5 STATEMENT OF EXPERT OPINION

¹ Dr. Ken Kirby described the possibilities for additional water supplies in Friant districts.
Supplemental Report of Dr. Steven J. Deverel
E.D. Cal. No. Civ. 88-1658 LKK

Figure 1. Relation Of Water-Level Decline To Pumping Estimates For Chowchilla Water District. *The solid line represents the original relation developed by Dr. Schmidt. The dashed lines represent the water-level-pumping equation with incorporation of error described in Burt and others (2002).*

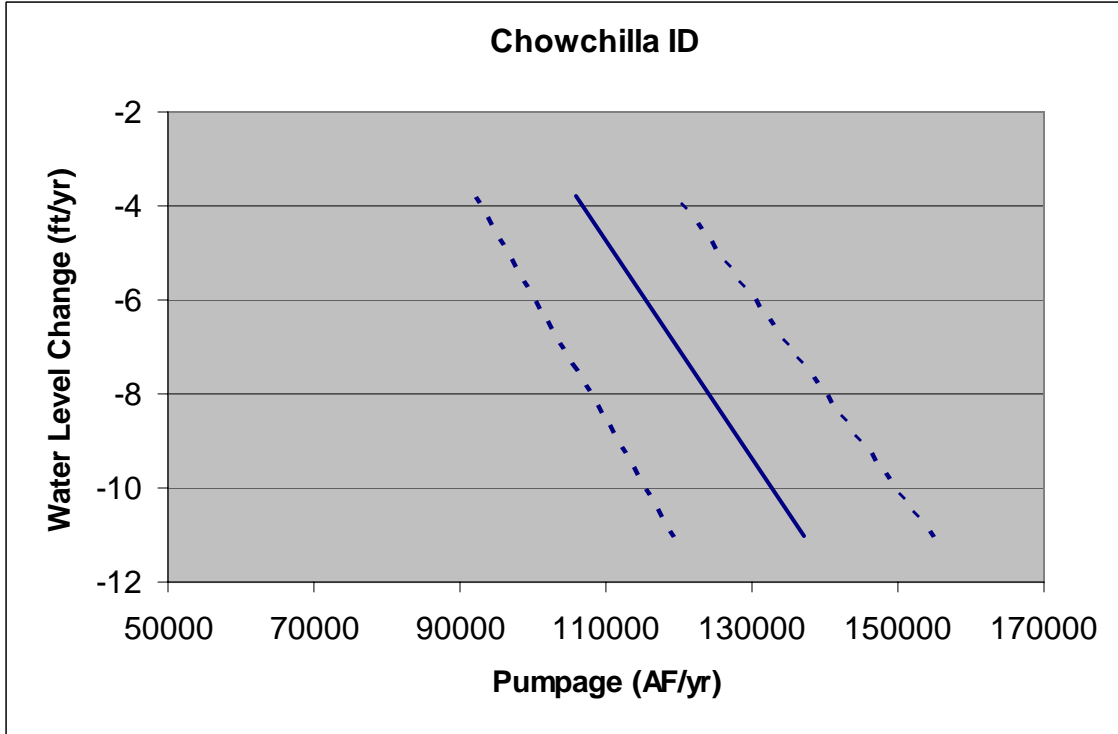
21. Alternatively, the uncertainty in estimated groundwater pumping can be examined by incorporating the $\pm 13\%$ uncertainty in the redevelopment of Dr. Schmidt's equations. In other words, we can determine how the straight-line equations would change if actual pumpage was different than estimated by Dr. Burt. Figure 1 illustrates the possible range in actual pumping causing the observed groundwater level decline in Chowchilla ID. To create Figure 1, the average annual groundwater pumping during 1987-1999 was adjusted by 13% and used to create uncertainty boundaries for the straight-line relationships developed by Dr. Schmidt. For example, the range in actual pumping causing the observed 4 feet per year groundwater decline is 90,500 AFA to 118,000 AFA.

22. Groundwater level changes were calculated from the uncertainty boundaries for pumping estimates of Schmidt's relationships for each water district. Table 2 shows that the potential uncertainty in groundwater pumping translates to calculated annual groundwater level declines that may vary by 1.2 to 22.4 feet per year.

Figure 2. Groundwater Contours And Generalized Directions Of Groundwater Flow For 1999. (Adapted from Department of Water Resources groundwater level map for the unconfined zone).

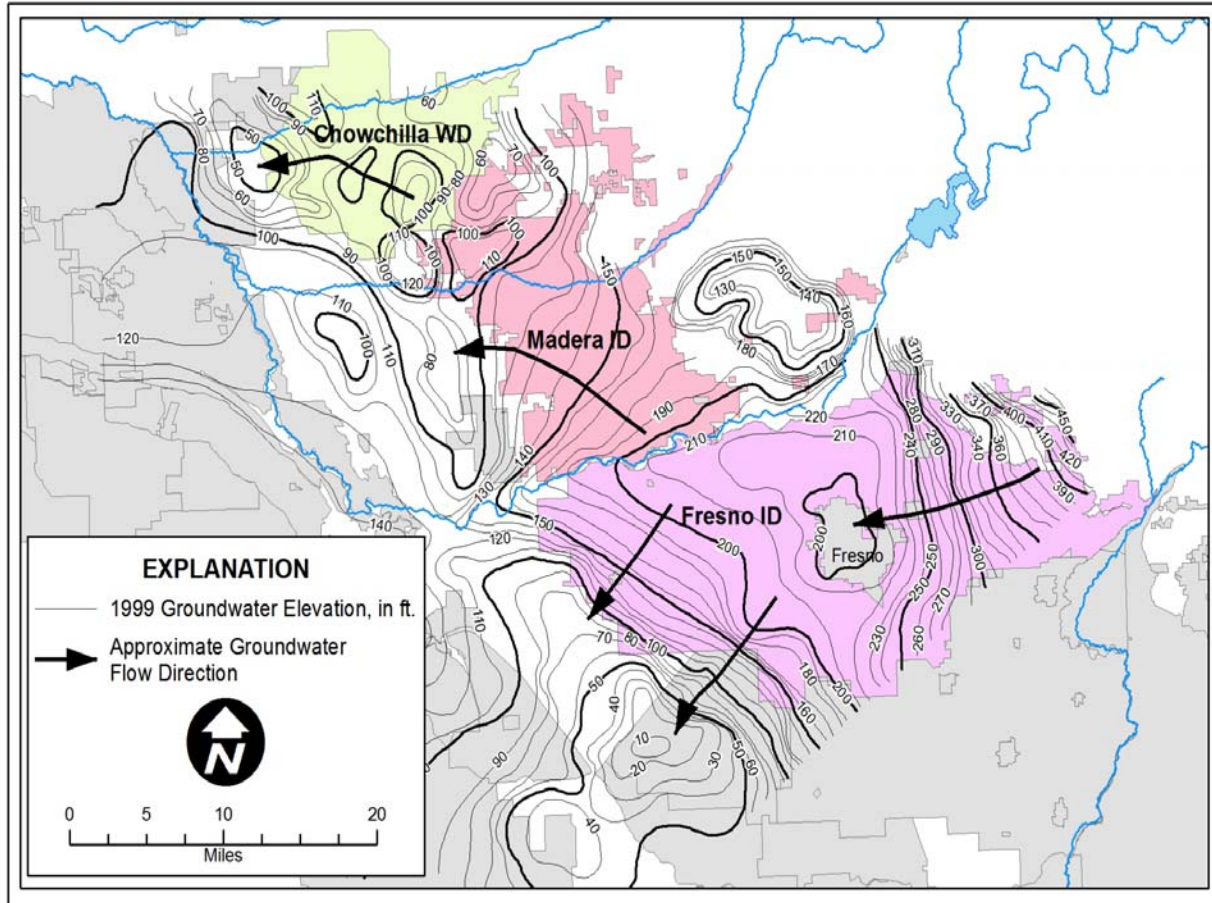
6 33. Figure 2 shows groundwater level contours developed by the Department of
7 Water Resources for 1999, a normal dry year. The contours show lines of equal groundwater
8 levels, from which the horizontal movement of groundwater beneath the subsurface is inferred;
9 groundwater moves from locations of relatively high levels to lower levels. The groundwater
10 level contour map shows that groundwater moves away from 3 Friant districts: Fresno,
11 Madera and Chowchilla. Throughout most of the Chowchilla Water District, groundwater
12 flow is generally east to west, and the groundwater level contours indicate water moves toward
13 a pumping depression located west of the district. Throughout most of the Madera Irrigation
14 District, groundwater flow is in a northwesterly direction toward a pumping depression located
15 west of the district. In the eastern part of the Fresno Irrigation District, groundwater flows

16 toward a pumping depression beneath the city of Fresno, and in the western part of the Fresno
17 Irrigation District groundwater flows toward a pumping depression located southwest of the
18 district. In another example, Fugro (2003) reported lateral groundwater flow leaving the
19 Kaweah Delta Water Conservation District which contains the Tulare Irrigation District, one of
20 the larger Friant districts.

Figure 3. Relation Of Measured Gains In Reach 4 To Deliveries.¹² Labels next to data points in show the year and water year type (W = wet, NW = normal wet, ND = normal dry D = dry).

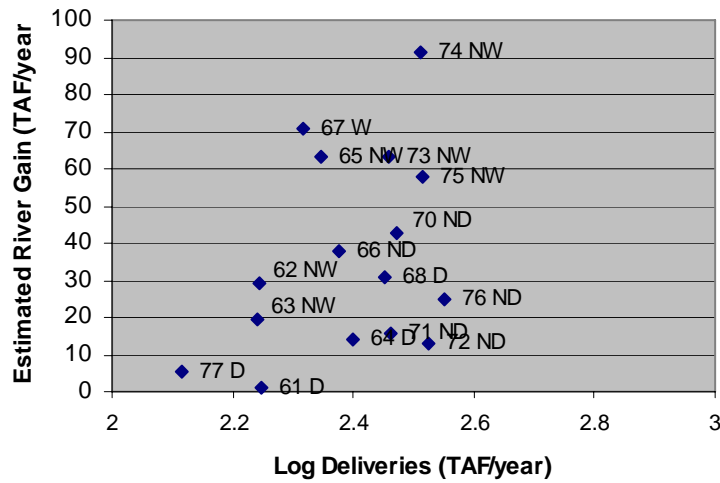
19 78. In my August 15, 2005 report, I described and showed the relation of Delta
20 Mendota Canal deliveries to river gains in Figure 1.22. I have subsequently determined that
21 some of the data used in the graph was in error. I now attach Figure 3 and provide the
22 following as my correct opinion on this issue. My conclusion expressed on the relation of
23 estimated River gains in Reach 4 relative to deliveries has not changed. I elaborate here.

79. I related the magnitude of gain in River Reach 4 related to deliveries via the Delta Mendota Canal (DMC) and San Luis Canal from 1961 to 1977. Figure 3 shows the relation of annual river gains estimated by Mullen and Nady (1985) to annual deliveries to

Figure 4. Annual Deliveries From 1961 to 1977.

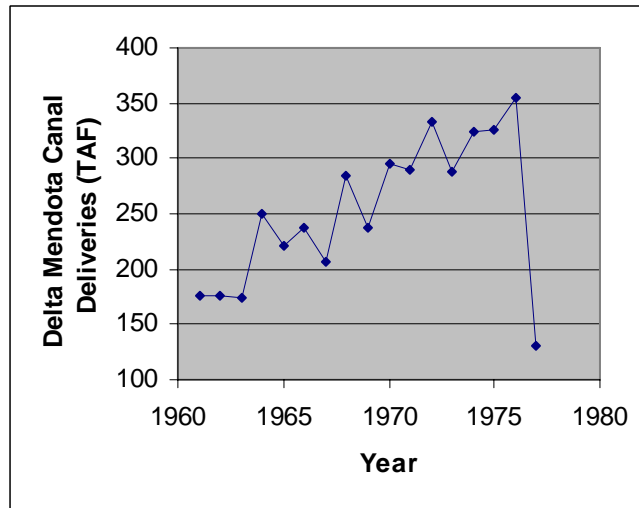
1 selected water districts via the Delta Mendota and San Luis Canals.¹³ These canals were
2 increasing deliveries during this time period in areas upgradient of River Reach 4 (Figure 4)
3 and probably contributed to increased groundwater levels. Figure 3 indicates that increasing
4 water deliveries may have contributed to increasing River gains in Reach 4. Specifically, gains
5 tend to increase with increasing deliveries. Figure 3 also shows that water year type also
6 substantially influences the relation. Dry and normal dry year types generally show indicate
7 less gain relative to deliveries. Wet and normal wet year types generally show more gain
8 relative to deliveries. In general, deliveries to the western San Joaquin Valley resulted in
9 increasing groundwater levels in the western San Joaquin Valley since the 1950's (Belitz and
10 Heimes, 1990).
